Re: Comprehensive Permit Application Under M.G.L. Chapter 40B, Sections 20-2
15 Riverdale Avenue/CPC Land Acquisition Company, LLC

Re: ZBA #01-20
Residences on the Charles
15 Riverdale Avenue
Newton, MA

We are in receipt of the Horsley Witten Group Peer Review dated March 25, 2020; revised May 22, 2020 issued for the proposed Residences on the Charles. The review indicates Horsley Witten Group's satisfaction with much of the information supplied by the Applicant, however, there are still several items where more information is required. On behalf of CPC Land Acquisition Company, LLC ("Applicant"), a wholly owned subsidiary of Criterion Development Partners, we have prepared this letter to respond to these outstanding items. The format of the following sections is as follows: comments excerpted directly from the peer review are included in italic font - with comments from the March review in the first paragraph and comments from the May review in the second paragraph. The Applicant's responses are provided in bold font and are prefaced by "R" and the applicable numerical designation.

EXH-1

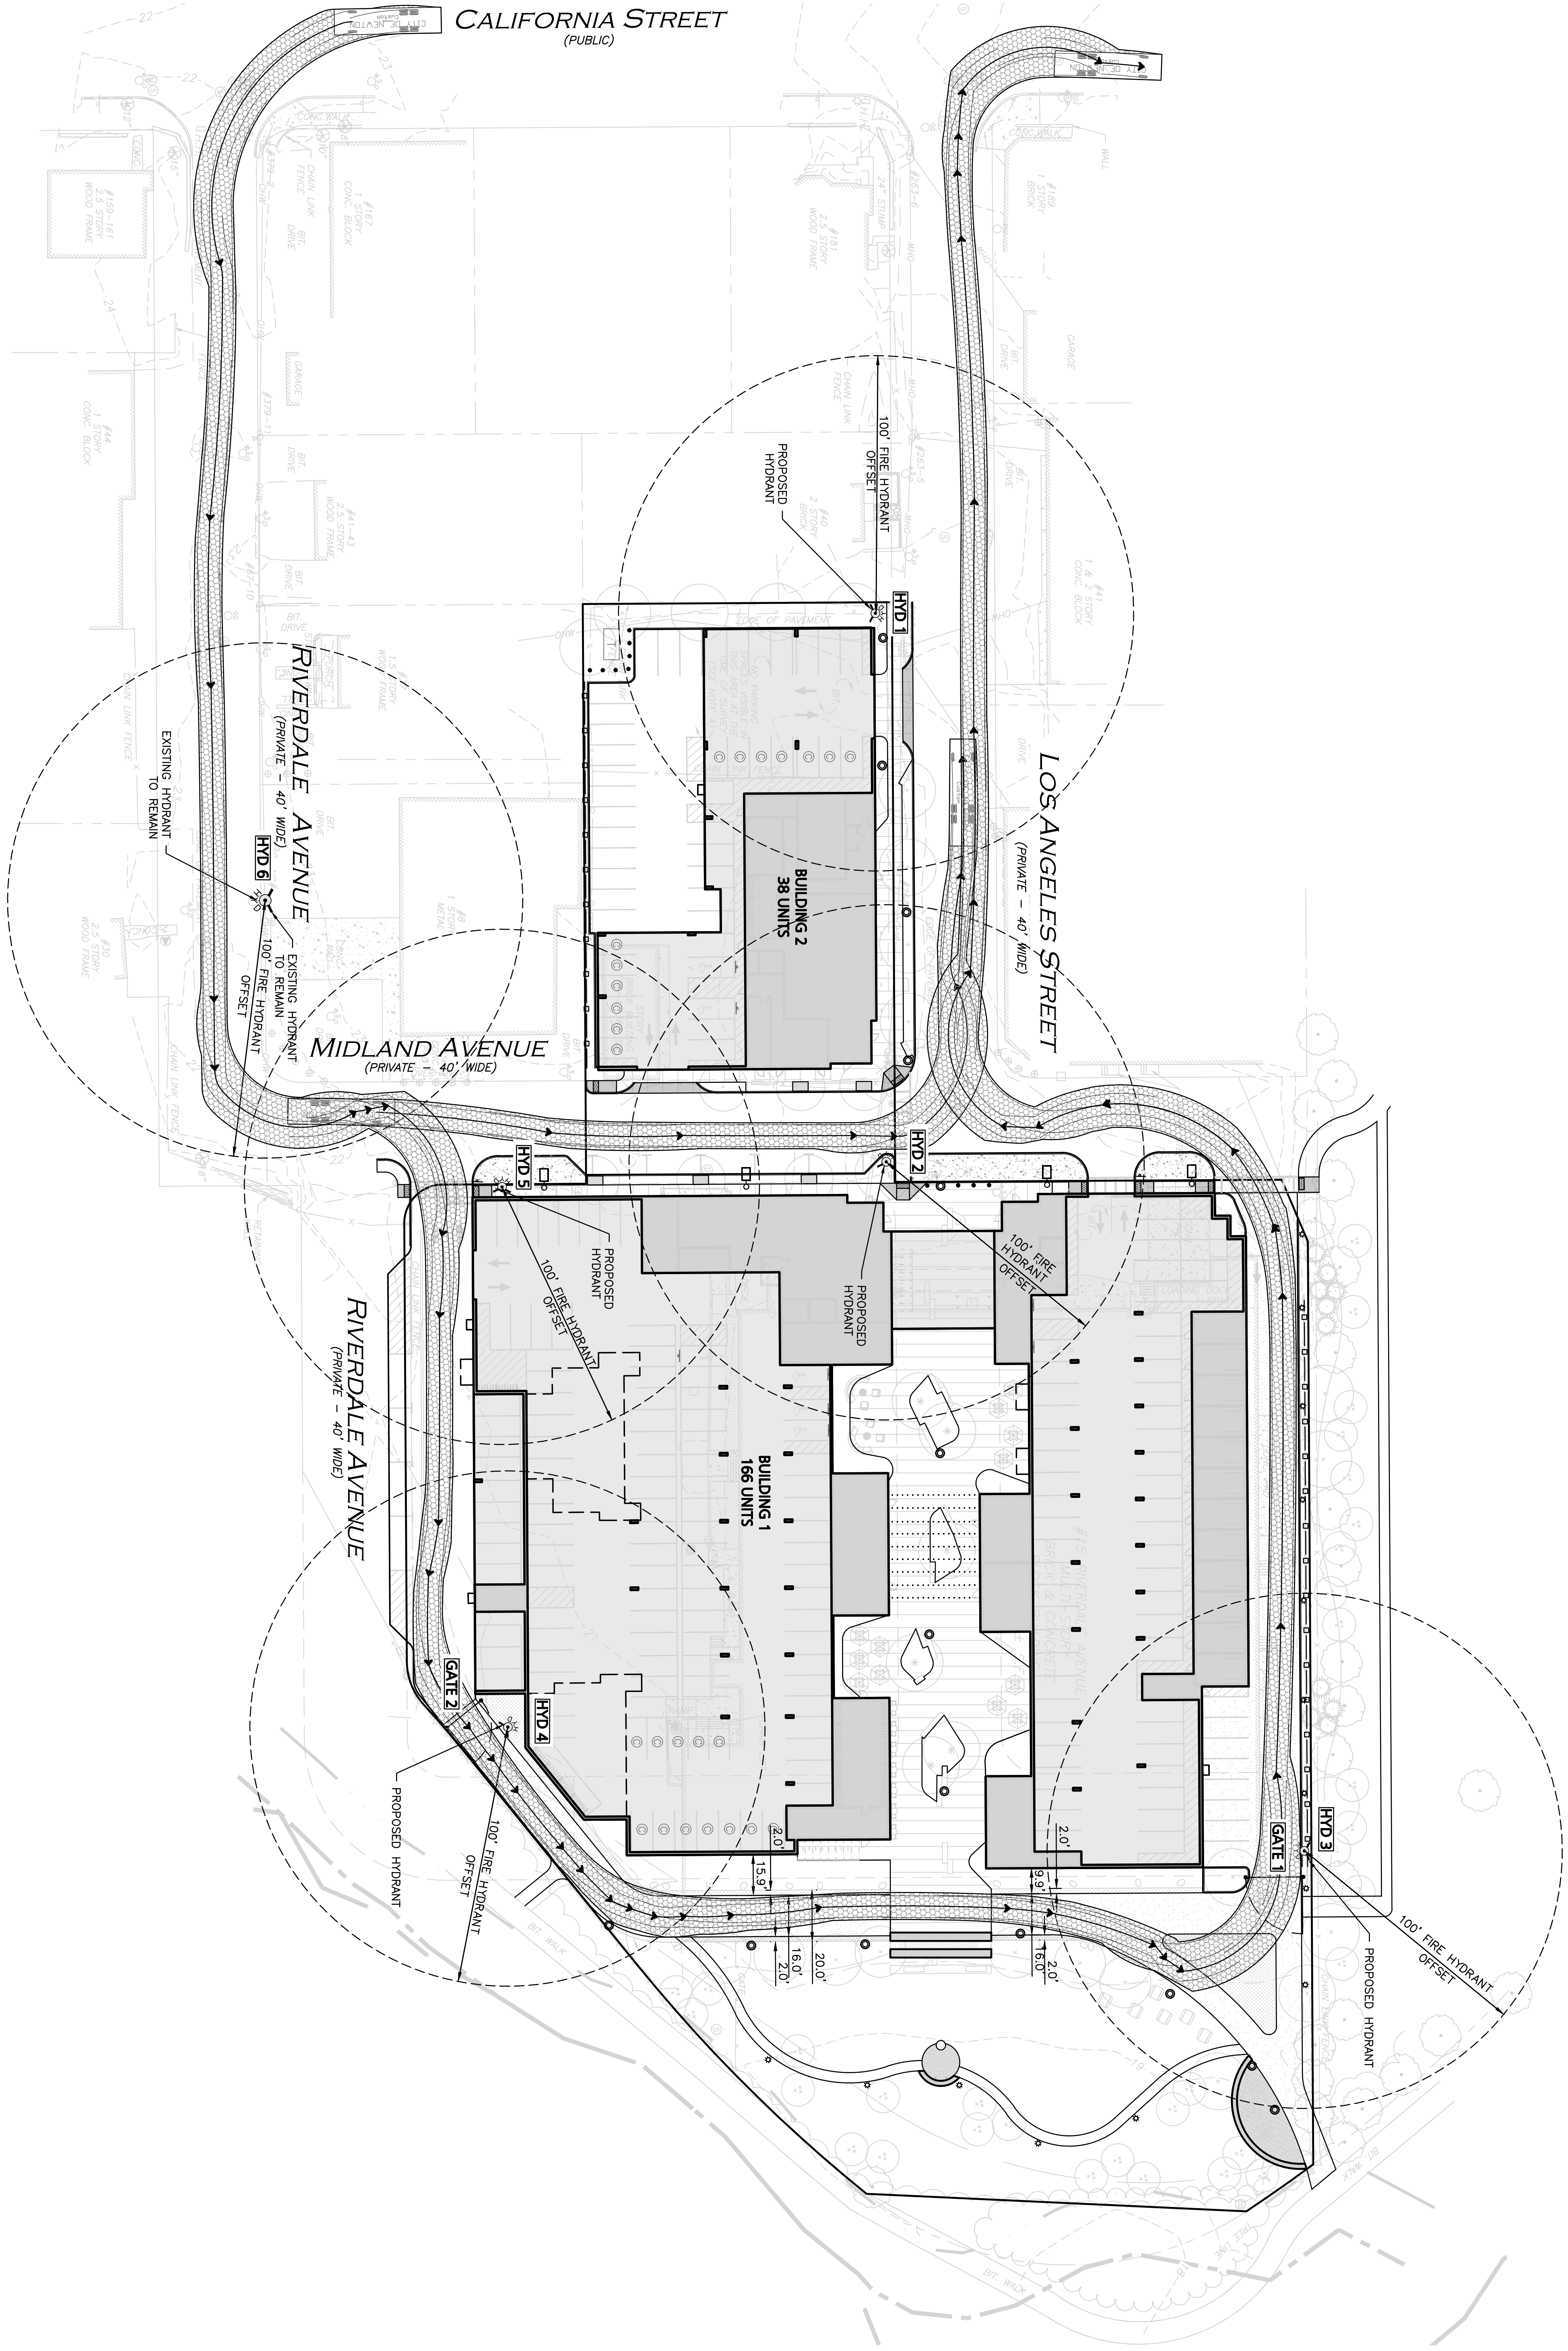
18. *The Applicant has proposed three fire hydrants closest to Building 1 and proposes to maintain an existing fire hydrant on Riverdale Avenue. HW recommends that the Applicant confirm that the Fire Department has reviewed the plans and is satisfied with the proposed locations.*

The Applicant stated it will meet with the Fire Department to confirm that the locations of the fire hydrants are acceptable.

R-18 The Applicant spoke with representatives of the Fire Department on May 4, 2020 and reviewed the proposed hydrant locations. Based on input received at that meeting a revised plan was submitted to the Fire Department. The revised hydrant locations are shown on EXH-1 Fire Truck Turning Plan issued for review on May 18, 2020, a copy of which is provided in the Appendix.

RESIDENCES ON THE CHARLES
CONCEPTUAL SIGN PROGRAM

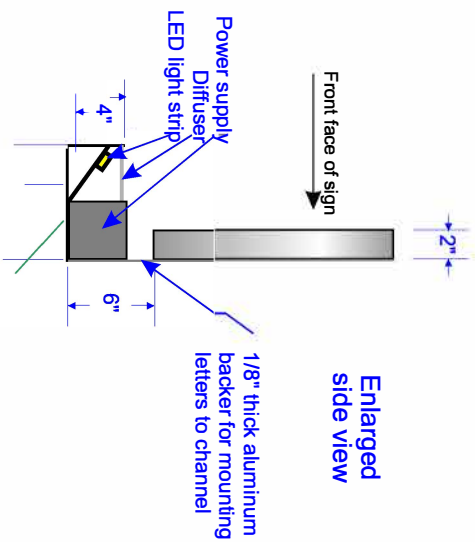
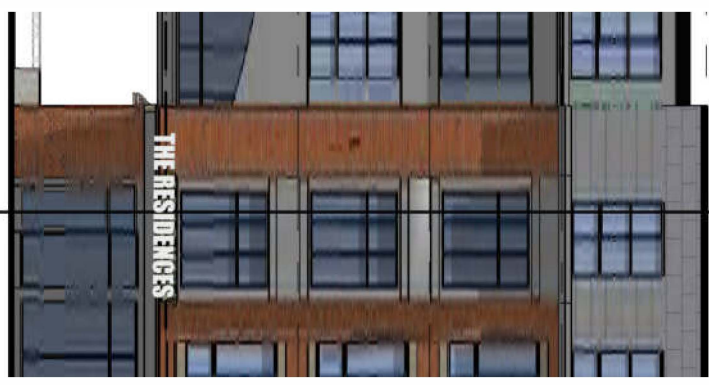
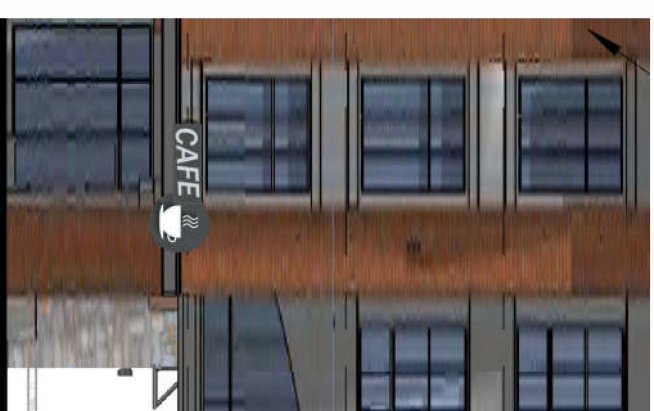
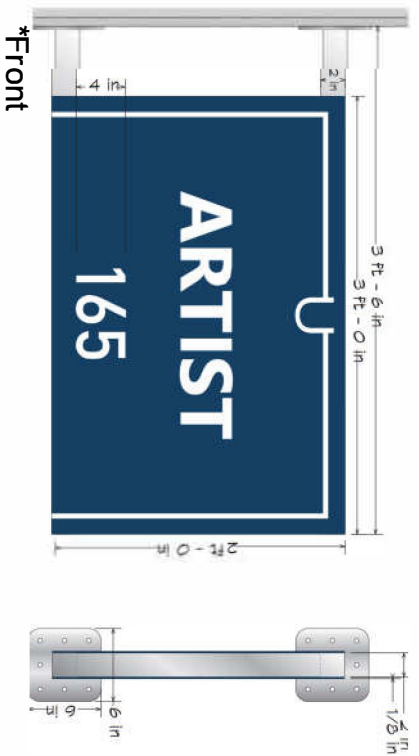
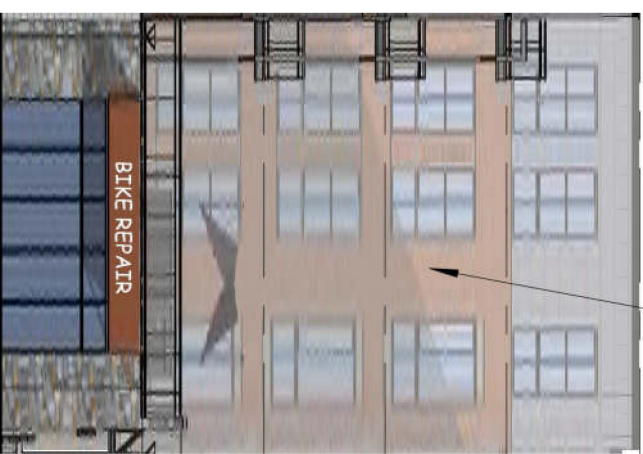
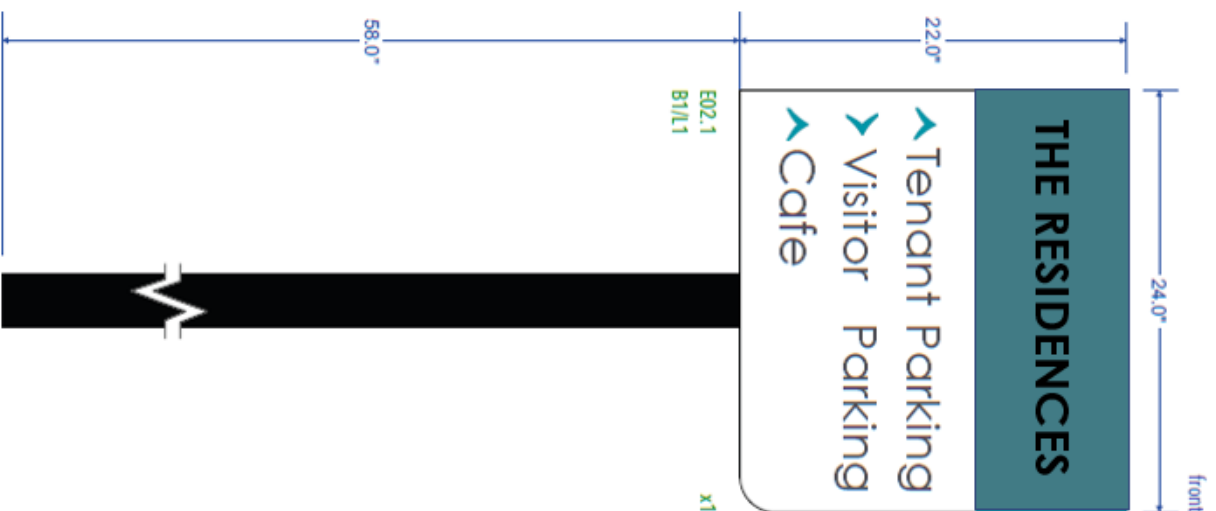
39. *To create an open space where the public feels welcomed into the outdoor area as well as through the pedestrian concourse, public amenities as well as wayfinding are critical. The various materials show a café but other amenities are not clear. The Applicant should clarify the intended users and programs for the pedestrian concourse and lawn area (i.e. will there be bike and kayak rentals, play spaces and public bathrooms for use). The Applicant should also clarify if there will be wayfinding, such as signage, directing people to the amenities, either on the DCR path or on California Street.*

The Applicant revised the plan set to identify public spaces and tenant areas. Signage will be provided at both ends of the courtyard. Additional detail should be provided for future review.

R-39 A conceptual sign plan package was recently submitted to the Planning Department and is provided in the Appendix. When available, a formal sign plan application will be submitted to the City's Urban Design Commission for review and approval.
